Amendments to the Drawings

Appl. No. 10/662,624 Amdt. Dated July 20, 2005 Reply to Office action of March 28, 2005

Appl.No. 10/662,624 Reply to Office action of 03/28/2005 Annotated Sheet Showing Changes

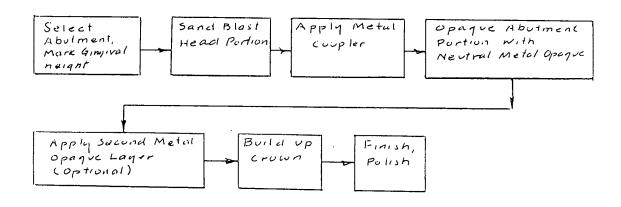
The attached sheets of drawings includes changes to sheet 2, Fig. 2. Sheet 2 includes

Figs. 2 and 3 and replaces the original sheet 2 including Figs. 2 and 3. Figure 2 has been

changed by adding previously omitted numeral 24 along with broken away section

labeled 24g, previously referenced in the specification.
